Grading Exceptions as revised 11/21/06

Name: Sanda-Guthrie, LLC
Address: 4225 Garner Road
Riverside, CA 92501
Project Name: TM 31930
APN: Portions of 243-180-003 and all of 243-018-004, 014 & 243-019-002

HEARING DATE: December 19, 2006

**SIGHT LINE SECTIONS
GUTHRIE TRACT 31930**

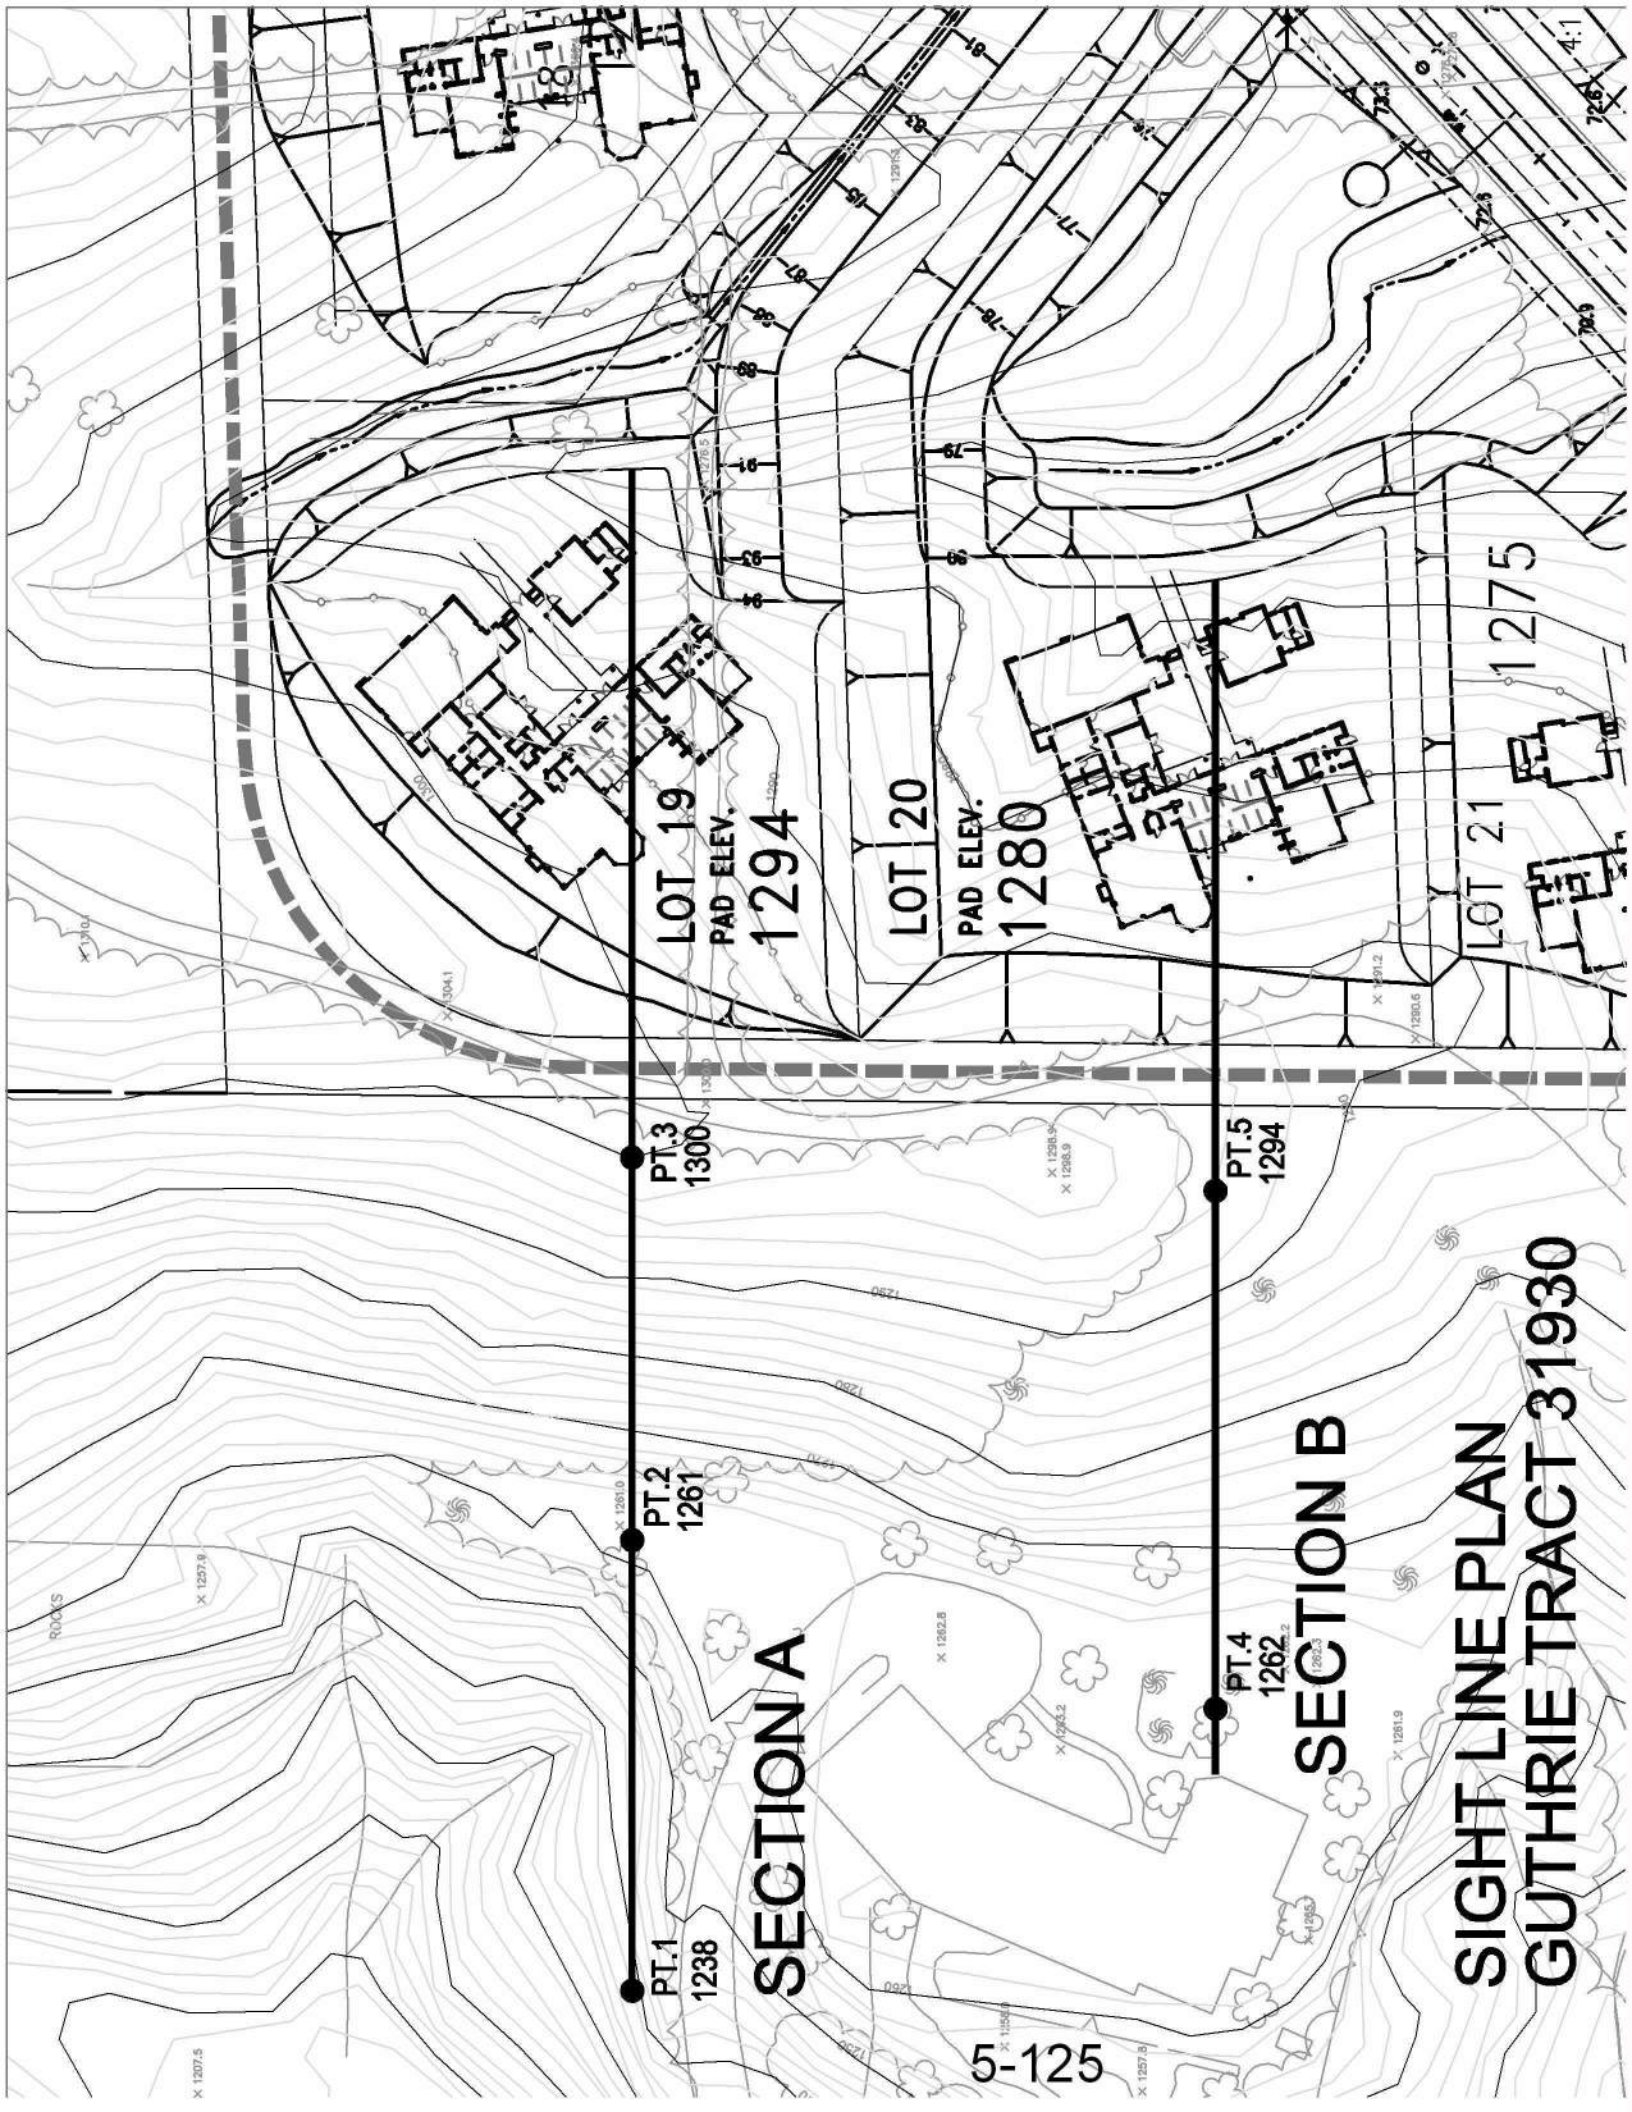
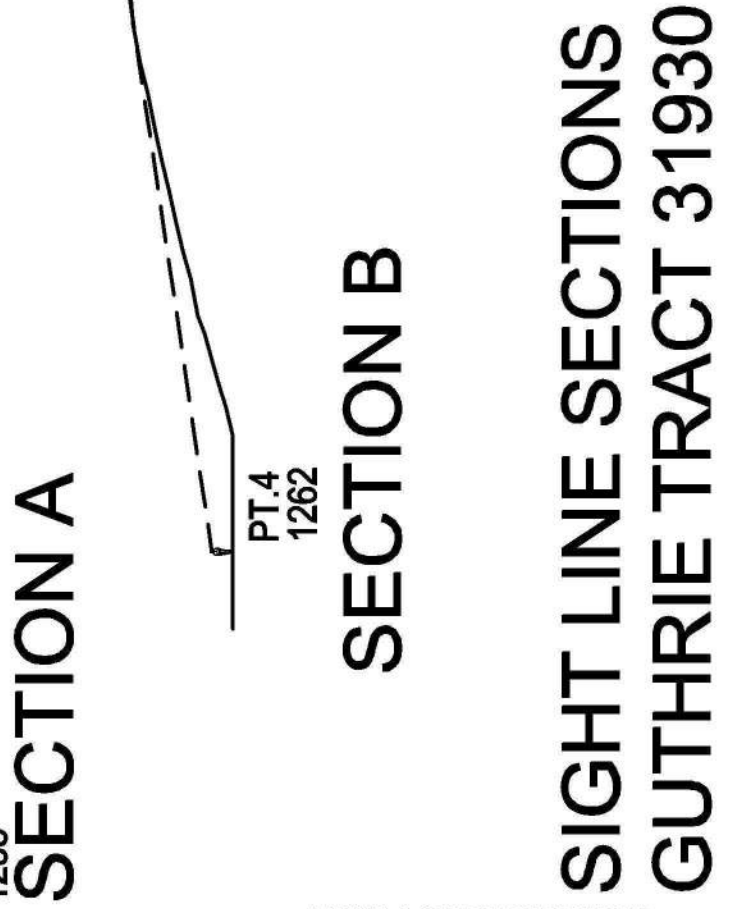
feet to 1294 feet. As previously required the developer was not allowed to grade a pad in this area above 1280 feet. The requested pad levels are directly against the previously 1280 elevation level recommended by the Planning Department and as required by the City Council. This requested elevation change goes against our City zoning code, and the intent of same as to the ridgelines, hillsides and other sensitive matter.

In planning and interpreting the rules, the "devil is always in the detail." In this case, Mr. Guthrie's overall plan is sound, but certain detail needs to be modified, specifically lots 19, 24, and 25. The elevation of lot 19 should be dropped 14 feet to insure structures there are below the ridge line. This protects the ridgeline and insures that precedent is maintained for adjacent projects proposed to the north of the Guthrie property.

We are back now another time to request that this contractor developer be required to eliminate open space and ridge line encroaching lots **24** and **25** and to limit the height of lot grading (especially lot **19**) to elevation 1280.
